REMARKS

Claims 1-17 are pending in this case. Claims 1, 2 and 6-8 have been rejected. Claims 3 - 5 and 9 have been objected to. Claims 10 - 17 have been allowed. Claims 1, 3 and 9 have been amended to more particularly point out the subject matter claimed by the Applicant as his invention. No new matter has been added.

Figure 1

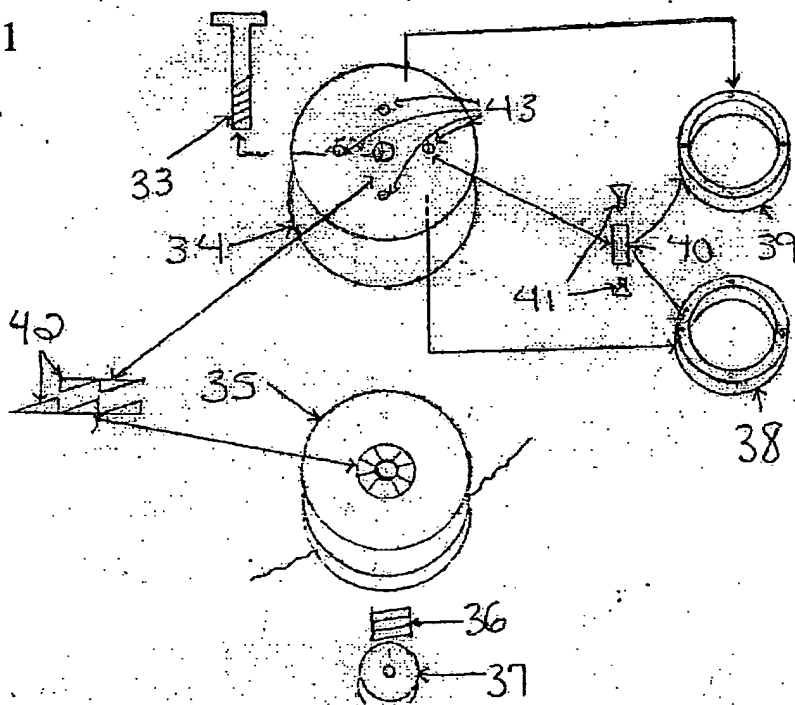
The Examiner has objected to the drawings. Figure 1 has been amended to more clearly show the location of the bottom ring 38 as being underneath the top surface of the spool housing 34 and top ring 39 being above the top surface of the spool housing 34.
